Addendum # 2

Bid Opportunity: 25-7630-RFT - Laurentian Public School HVAC and Building Controls Upgrade

GROUND FLOOR PART PLAN 'A' – PIPING DEMOLITION
 SCALE: 1:100

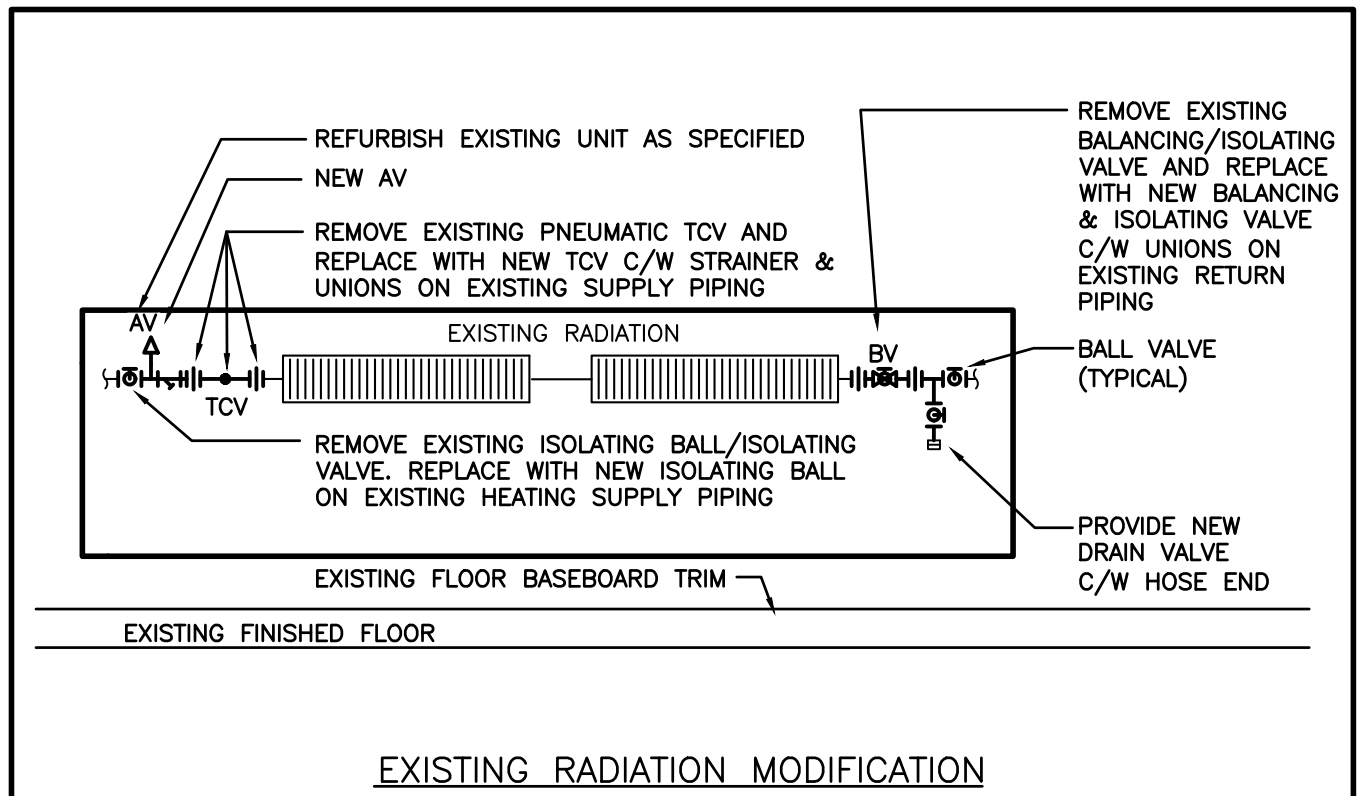
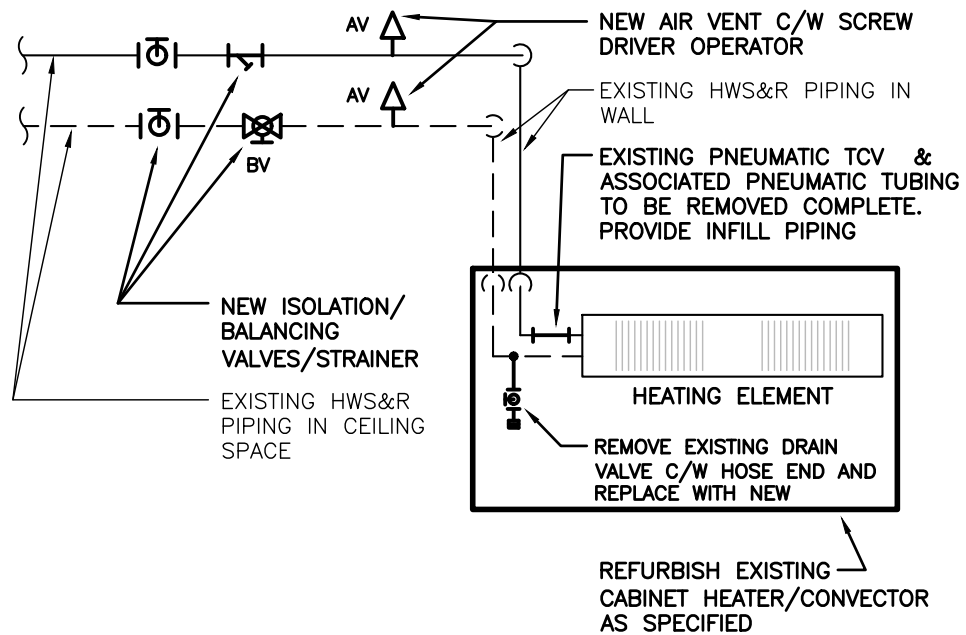
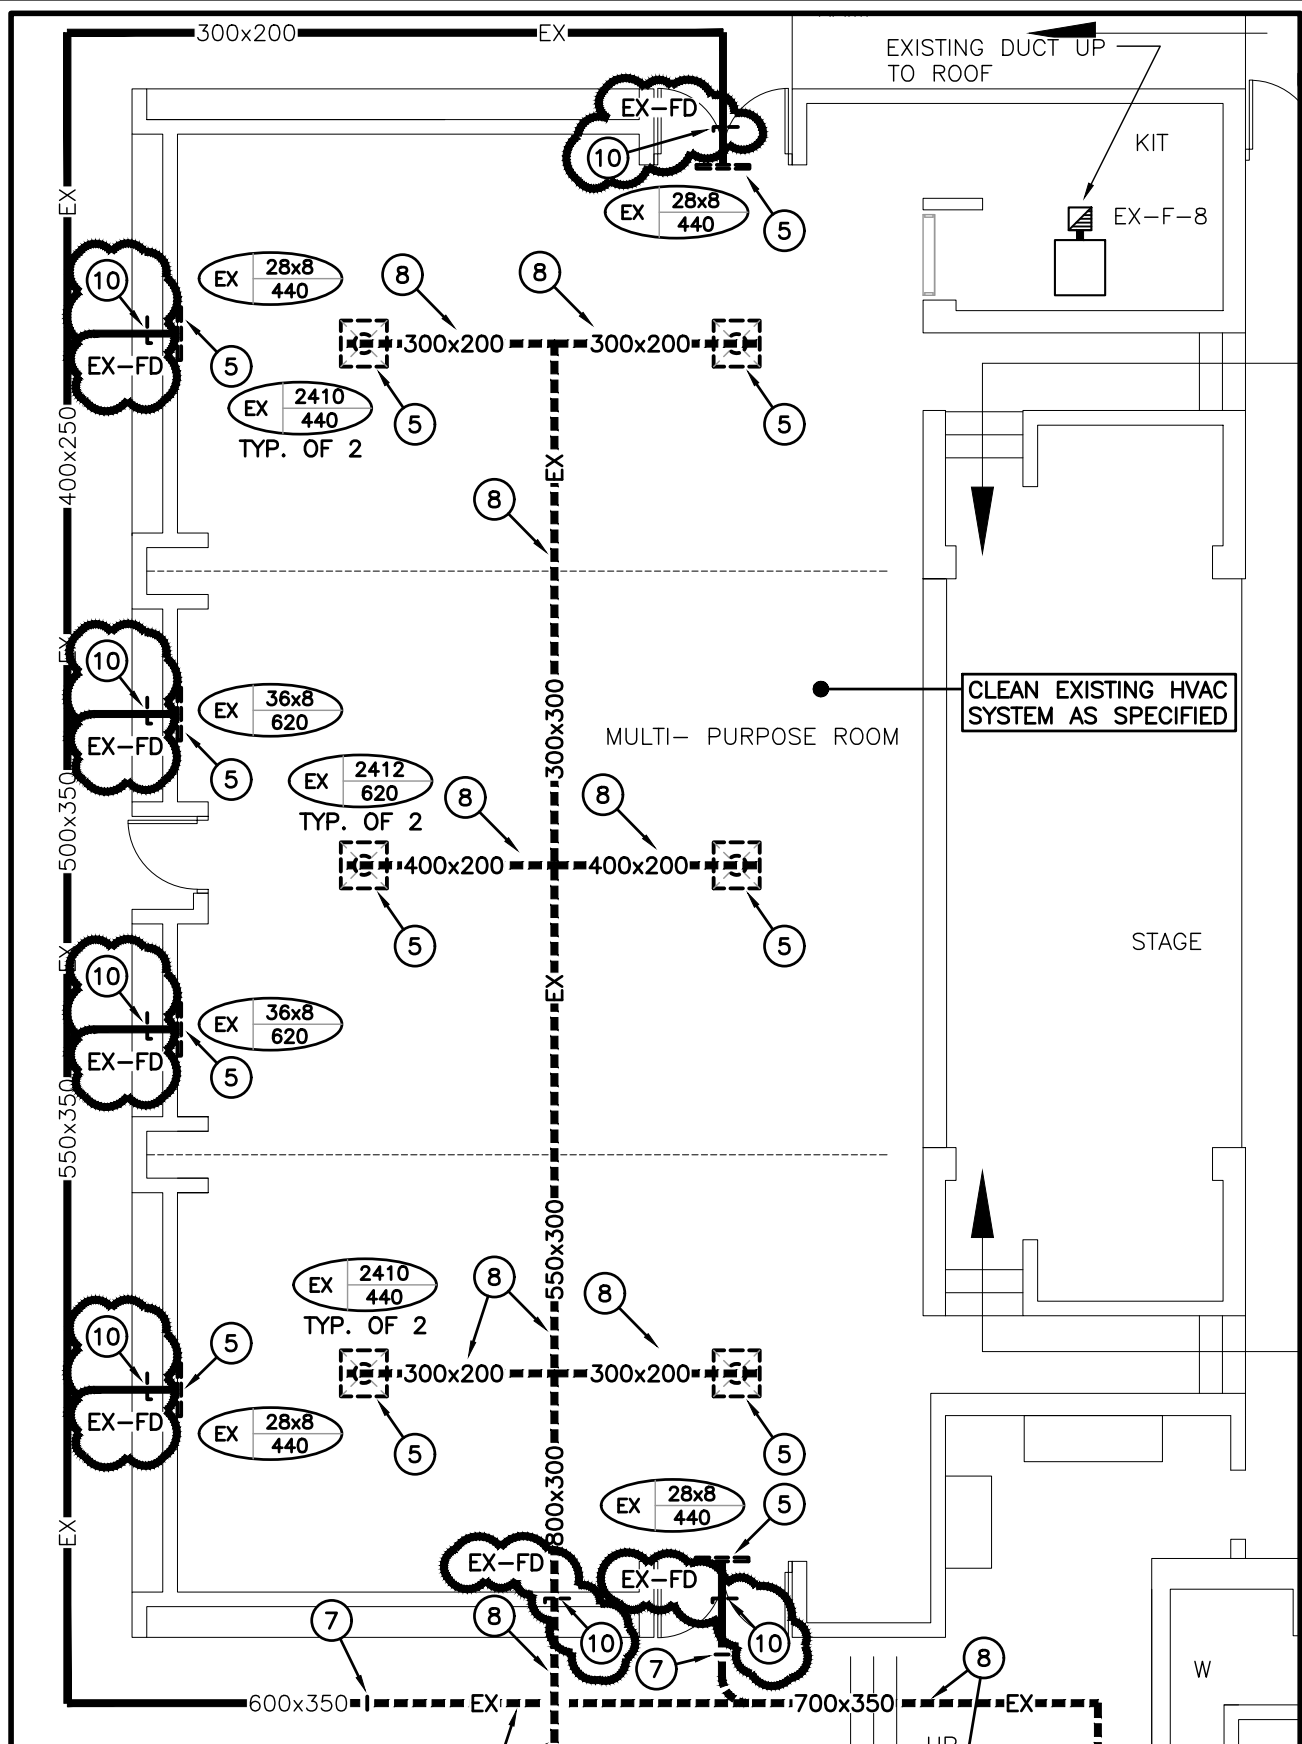
4.0 Reference Drawing M201 and Attached Sketch AD02-M01

- .1 In existing corridor, remove existing valves and thermostats as indicated on attached sketch AD02-M01.

8.0 Reference Drawing M204 and Attached Sketches AD02-M03 and AD02-M04

- .1 In 'New Unit Ventilator Install Modification' detail, provide unions and strainer at temperature control valve and balancing valve.
- .2 In Computer Room 22, provide new radiation trim/lap pieces on radiation to accommodate installation of new unit ventilator.
- .3 In existing corridor outside barrier free washroom and office, revise two (2) thermostats serving existing force flow to be concealed sensors/thermostats.
- .4 In existing corridor outside boys/girls washrooms, provide new concealed sensor/thermostat for new TCV in existing radiation.
- .5 Add 'Existing Radiation Modification' detail as indicated on attached sketch AD02-M03.
- .6 Add 'Existing Convactor/Cabinet Unit Heater Modification' detail as indicated on AD02-M04.

AD02-M06

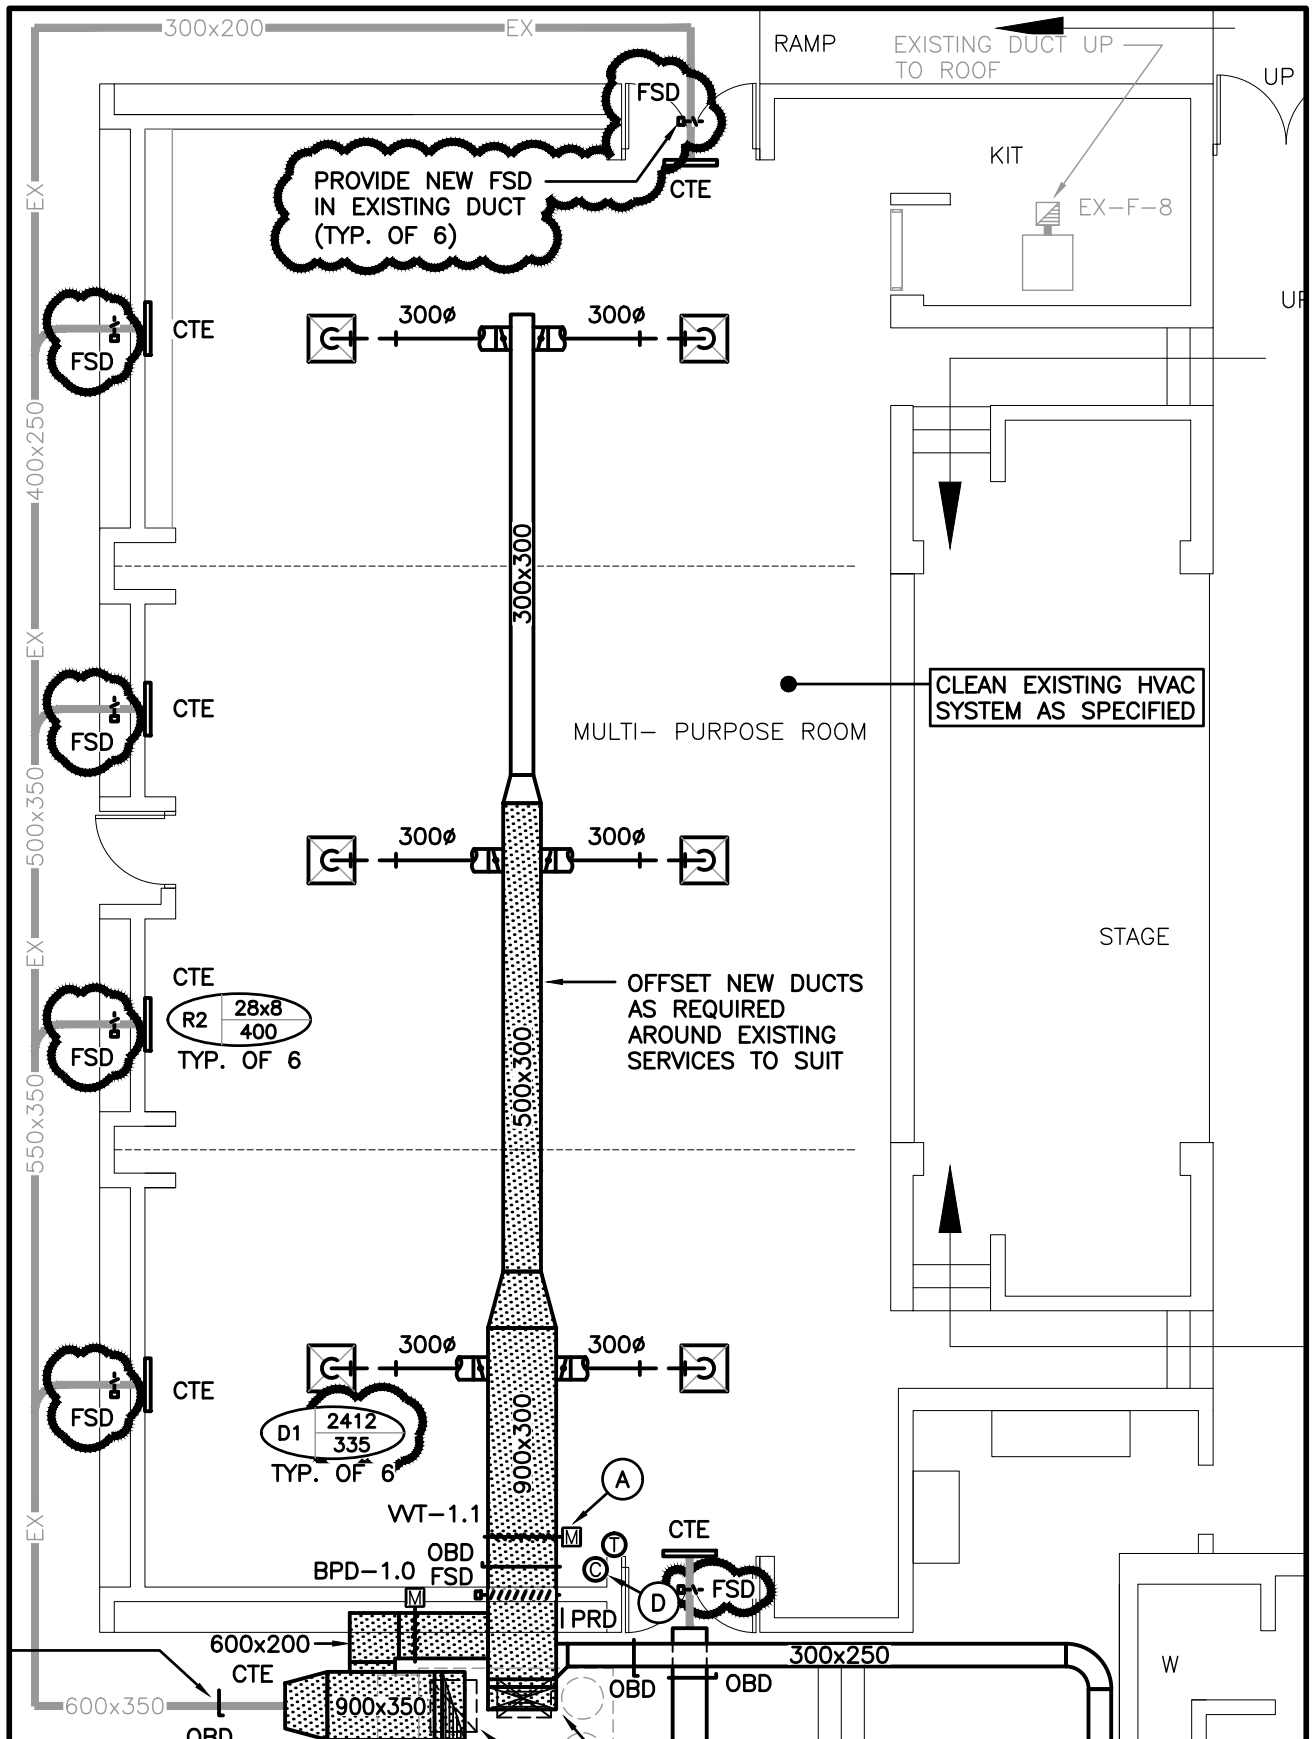
12.0 Reference Drawing M302 and Attached Sketch AD02-M06

- .1 In 'Specific Demolition Notes', add Note 9 as follows:
Existing fire damper to be removed completely.
- .2 Remove existing fire dampers as indicated on attached sketch AD02-M06.
- .3 In existing corridor outside multi-purpose room, temporarily remove/re-route existing services to accommodate new ductwork installation.

AD02-M07

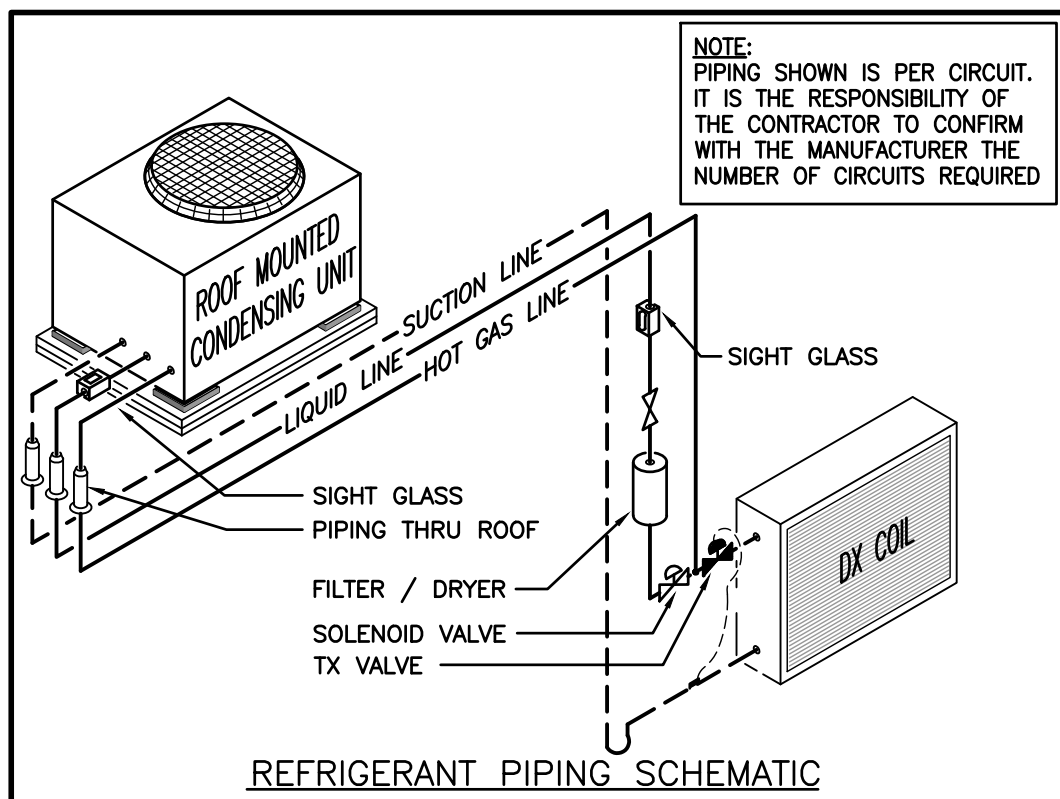
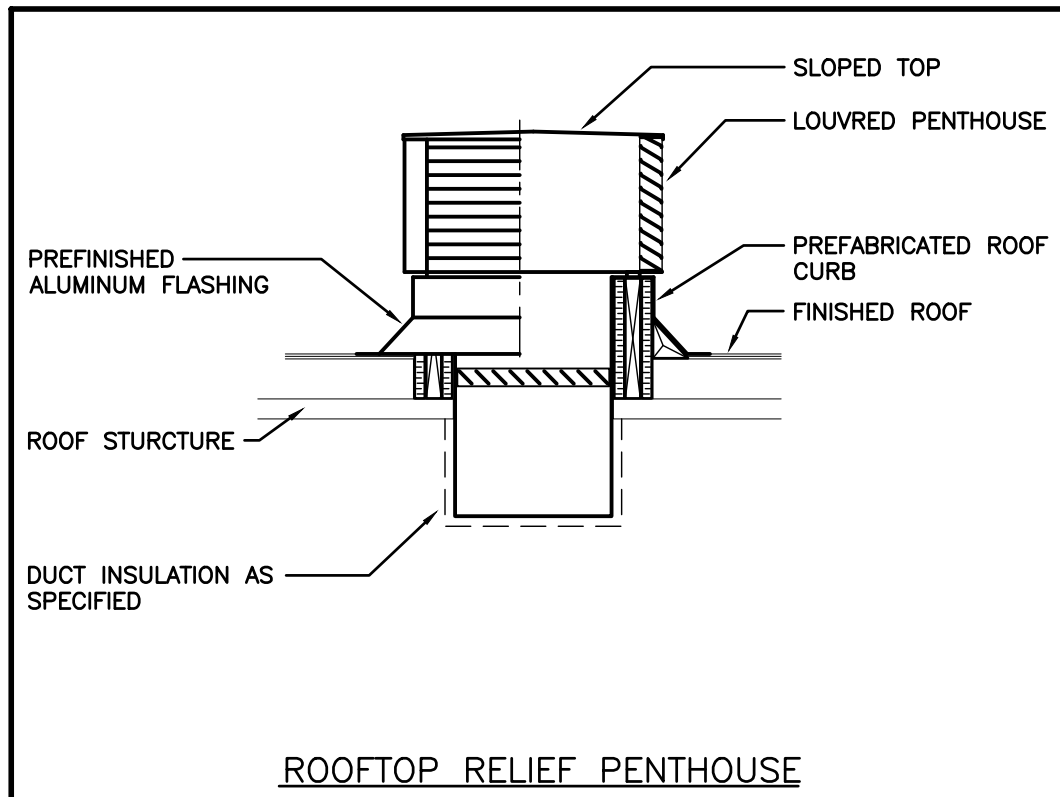
14.0 Reference Drawing M304 and Attached Sketches AD02-M07 and AD02-M08

- .1 Provide new combination fire/smoke dampers in existing return ductwork as indicated on attached sketch AD02-M07.
- .2 In multi-purpose room, revise capacity of six (6) new diffusers to 335cfm.
- .3 In existing corridor outside boys/girls washrooms, temporarily remove/reroute existing services to accommodate new ductwork installation.
- .4 In science tech, revise ductwork as indicated on attached sketch AD02-M08.
